UNITED STATES PATENT AND TRADEMARK OFFICE

APPLICATION NO.	FILING DATE	FIRST NAMED INVENTOR	ATTORNEY DOCKET NO.	CONFIRMATION NO.
10/588,006	09/20/2006	Quentin Baillia-Prel	0579-1128	1367

Office Action Summary	Application No. 10/588,006	Applicant(s) BAILLIA-PREL, QUENTIN	
	Examiner CARLOS LUGO	Art Unit 3673

DETAILED ACTION

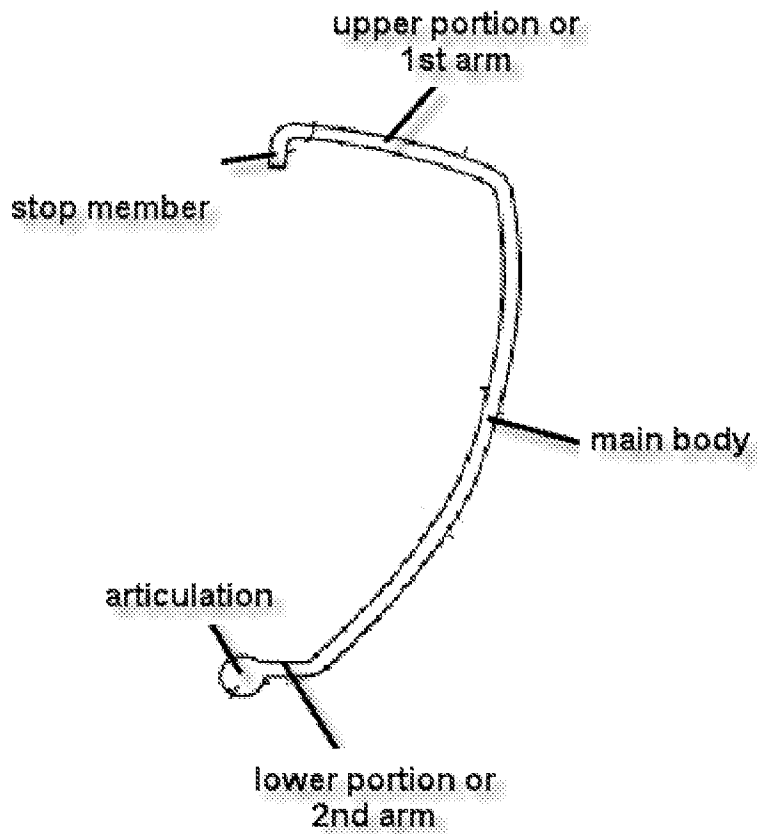
Hoffman discloses a “panic” bar assembly comprising a fixed part (12) having 1st and 2nd abutments; a bolt operating member (22 and 24) that will operate a bolt (30); and a crash bar (13).

The crash bar comprises a main body having a pivoting end (at 16) and a stop member (17) at the opposed end. The device creates a housing for covering the members of the fixing plate and the crash bar (attachment #2).

Attachment #1

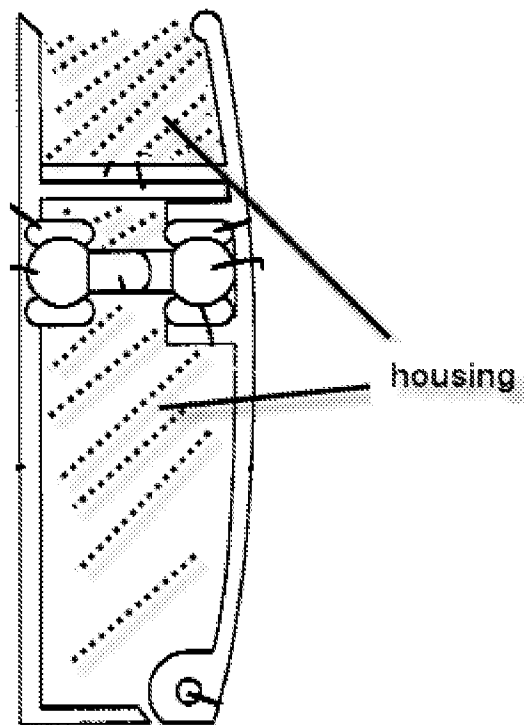
As clearly described and illustrated, the crash bar (4) has a main body, an upper portion or first arm extending from one end and a lower portion or second arm extending from the opposite end, a stop portion extending from the other end of the upper portion and an articulated member (bead) extending from the other end of the lower portion (attachment #1). A broad interpretation will be given to the claim language. Correction is required.

Instead of complicating the claim language with indefinite terms, the applicant is required to use the same terminology used in the specification (see 112 section for a clean and simple interpretation of the crash bar, attachment #1).
